Décarbonation énergétique LPF & BSST – draft P&ID

Projet Décarbonation LPF & BSST · drawing PID-LPF-BSST-001 · revision A (draft for review) · generated 2026-10-23

DRAFT — NOT FOR CONSTRUCTION
Every addition is pending engineering review. Nothing was invented that the specification does not state.

PROJECT	DRAWING	SHEET	REV.	STATUS
Projet Décarbonation LPF & BSST	**Steam – flash tank and CMV compression train**	Sheet 5 of 8	A	**DRAFT – pending engineering review**

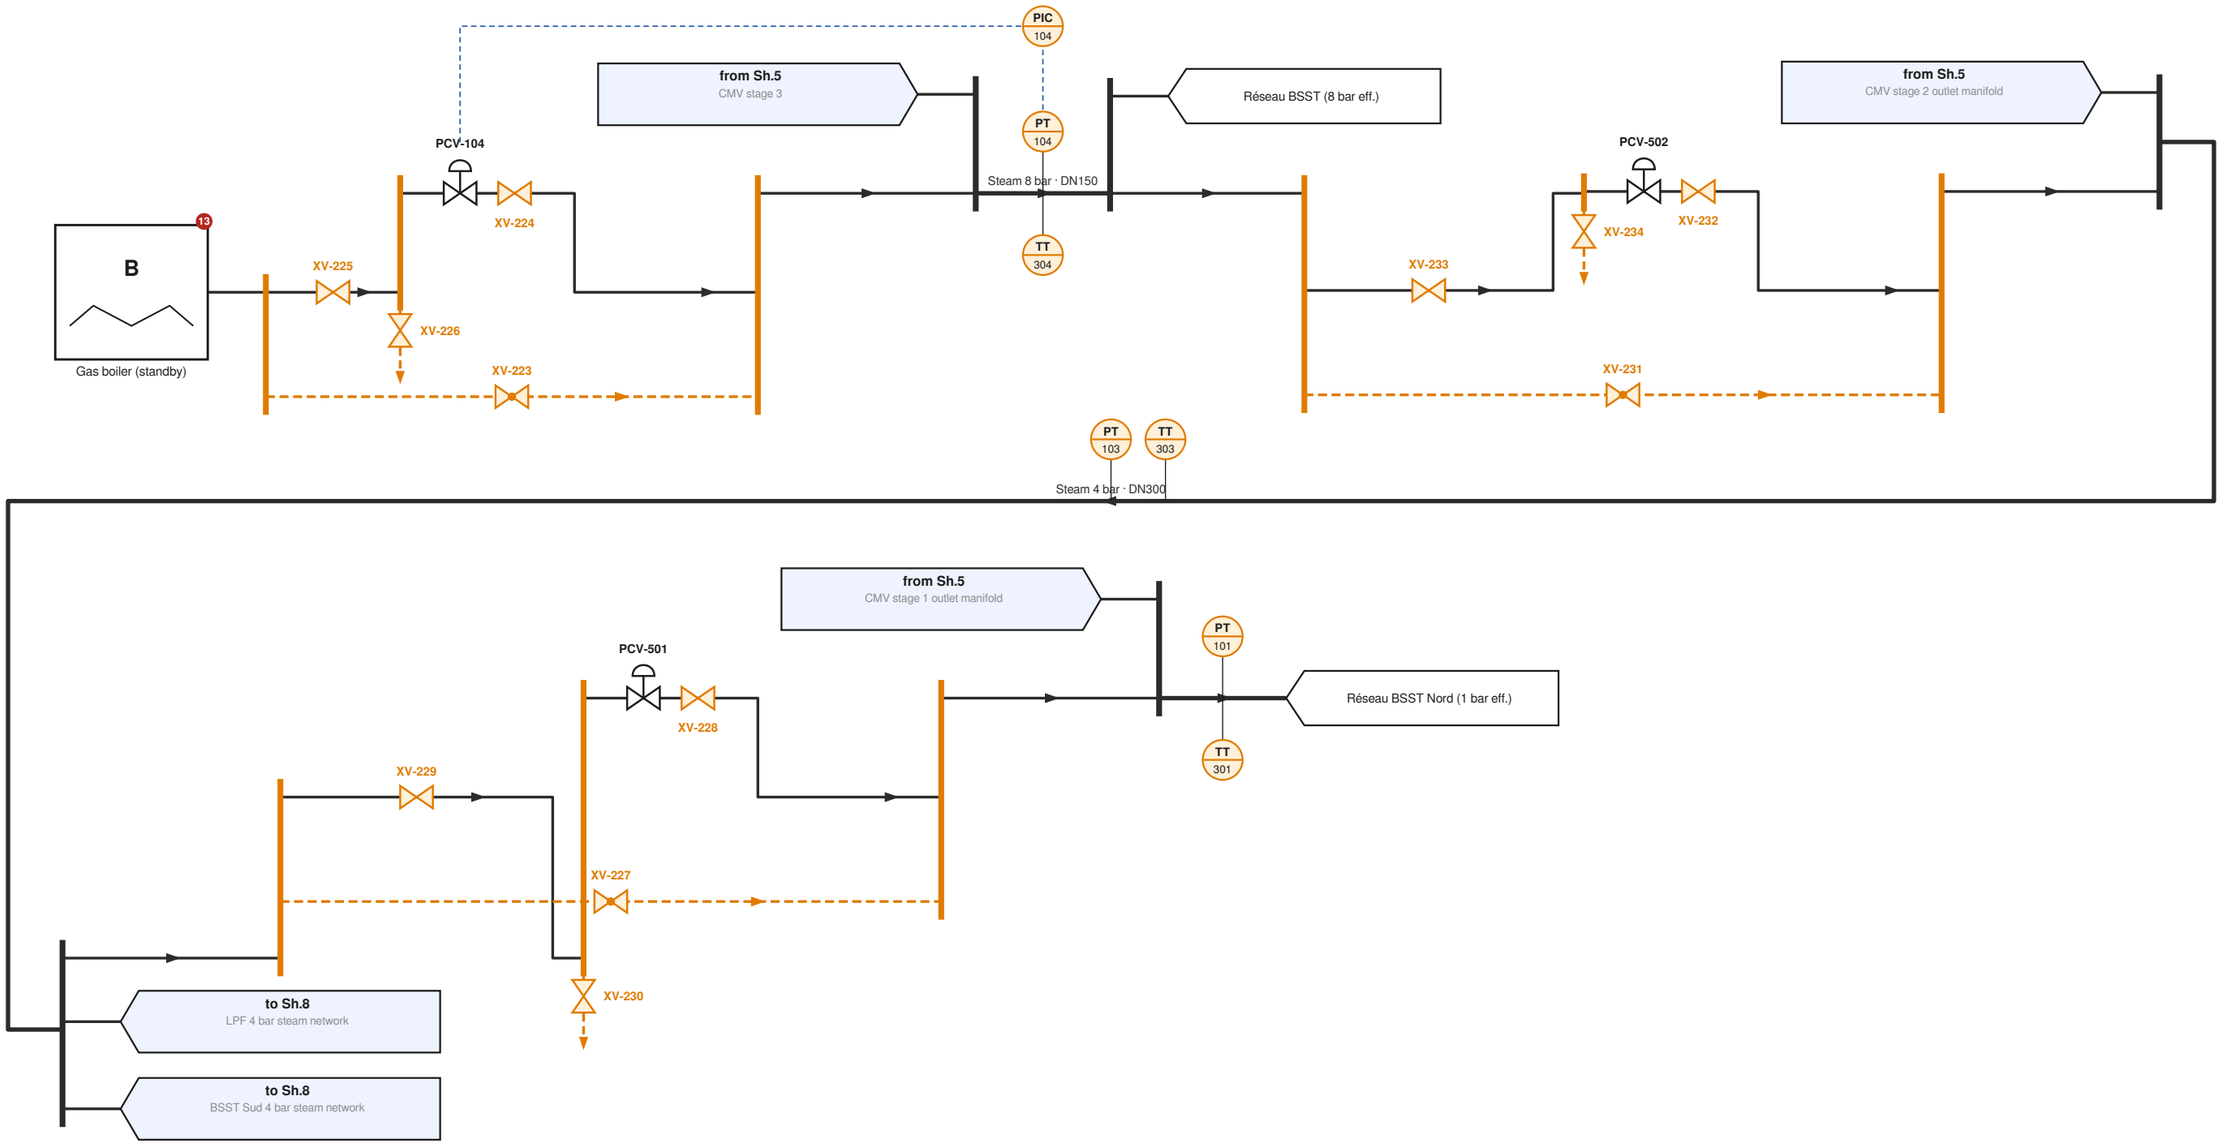
12. Spill valves 8 → 4 and 4 → 1 bar: controlled variable, measurement point, setpoint, valve technology and failure position are not stated, so no control loop is created for them.
13. Gas boiler: capacity, fuel/feed-water/flue connections, PCV technology and failure position are not stated.
21. Valve technology is not specified for these valves. They use the explicitly identified generic DEXPI representation (CustomOperatedValve, 'technology to be selected'); no specific valve type was chosen.
22. Failure position (fail open / close / retain) of the control valves is not specified and was not assumed.

PROJECT	DRAWING	SHEET	REV.	STATUS
Projet Décarbonation LPF & BSST	**Steam headers, 8→4→1 bar spill cascade and back-up boiler**	Sheet 6 of 8	A	**DRAFT – pending engineering review**

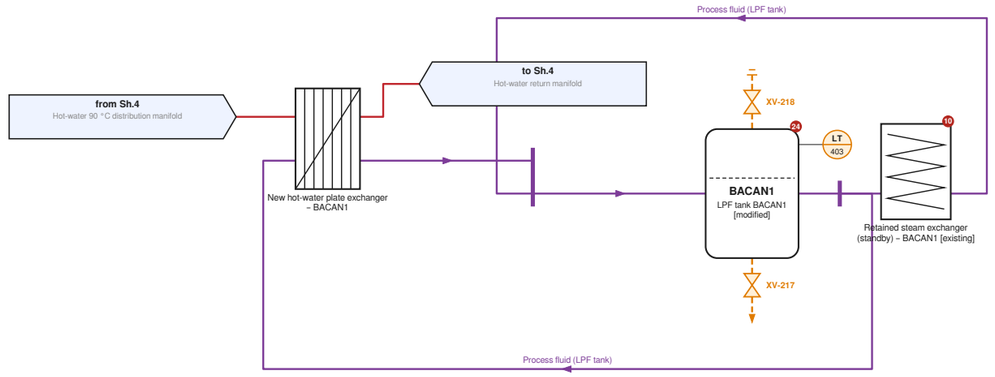
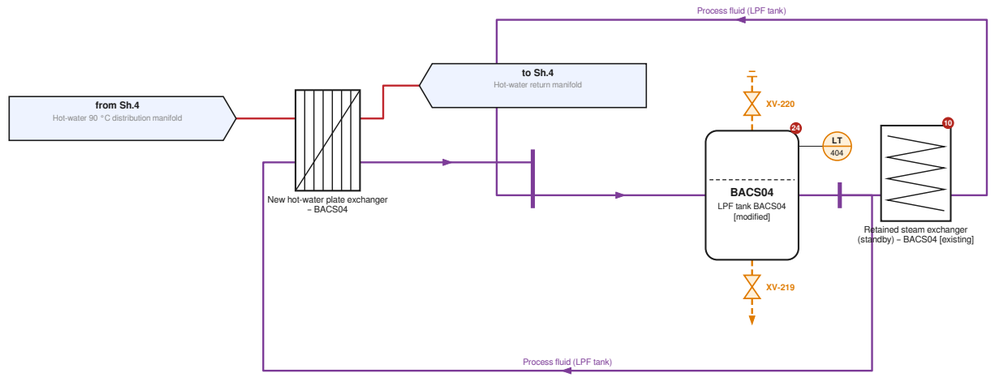
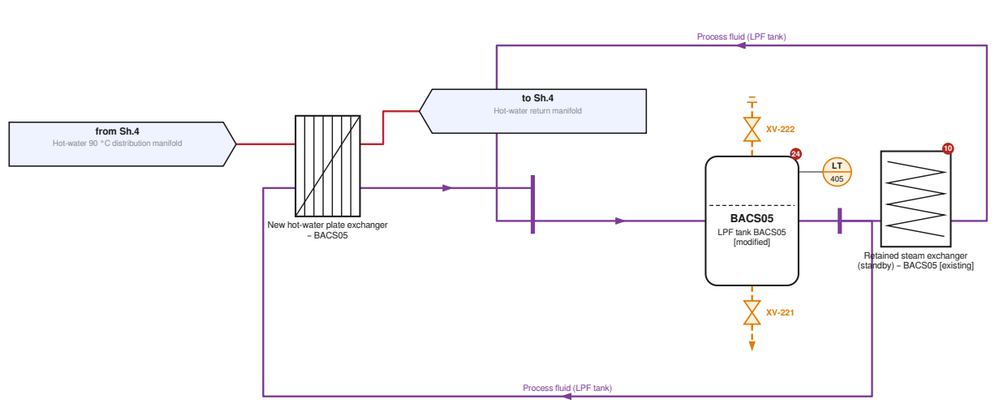
10 LPF tank heating loops: the circulation pump, fluid and steam supply of the retained steam exchangers are not described; their steam/condensate nozzles are left open.

21 Valve technology is not specified for these valves. They use the explicitly identified generic DEXPI representation (CustomOperatedValve, 'technology to be selected'); no specific valve type was chosen.

24 Nozzles added for drain, vent and level tapping have no nozzle number and no size.

PROJECT	DRAWING	SHEET	REV.	STATUS
Projet Décarbonation LPF & BSST	**LPF tanks – hot-water heating with retained steam exchangers**	Sheet 7 of 8	A	**DRAFT – pending engineering review**

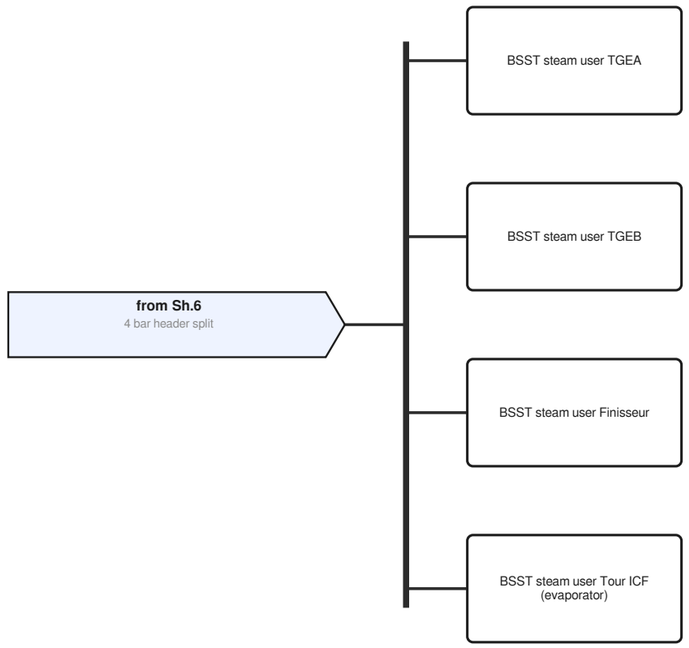
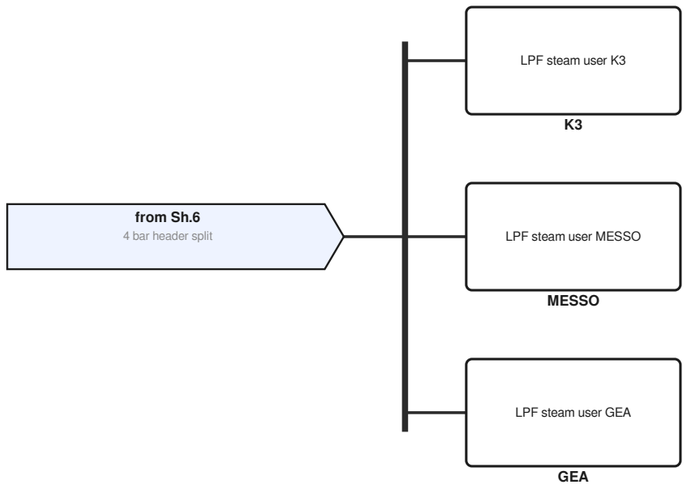
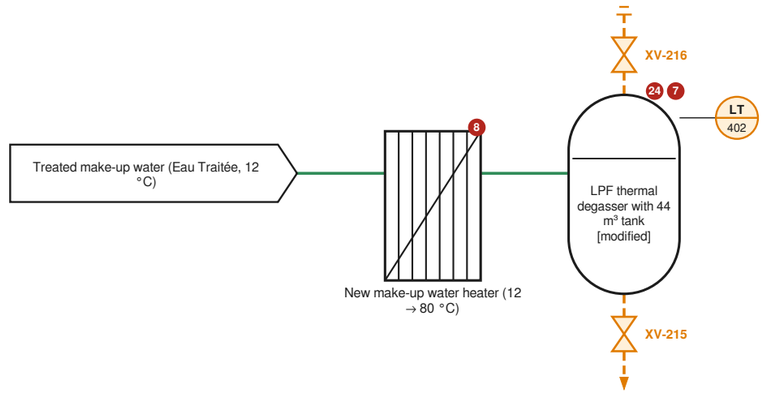
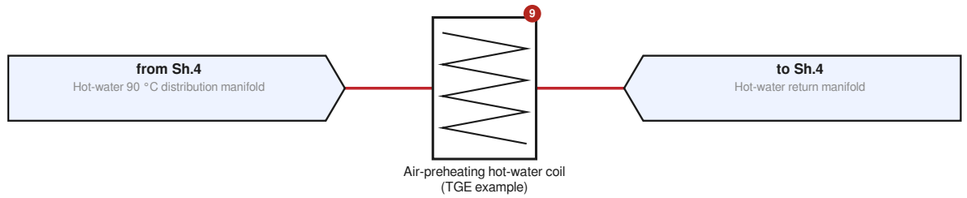
7. Degasser steam supply: '4 bar ou 1 bar eff. (à définir)'. The steam inlet is left unconnected until chosen.
8. The heating medium and connection of the new make-up water heater (12 → 80 °C) are not stated; its hot side is left open.
9. Air-preheating coil: water inlet is limited to 85 °C (sanitary safety) while the process hot-water header is at 90 °C. No tempering/mixing arrangement is specified, so none is added. Only one example coil (TGE) is modelled; the number…
21. Valve technology is not specified for these valves. They use the explicitly identified generic DEXPI representation (CustomOperatedValve, 'technology to be selected'); no specific valve type was chosen.
24. Nozzles added for drain, vent and level tapping have no nozzle number and no size.
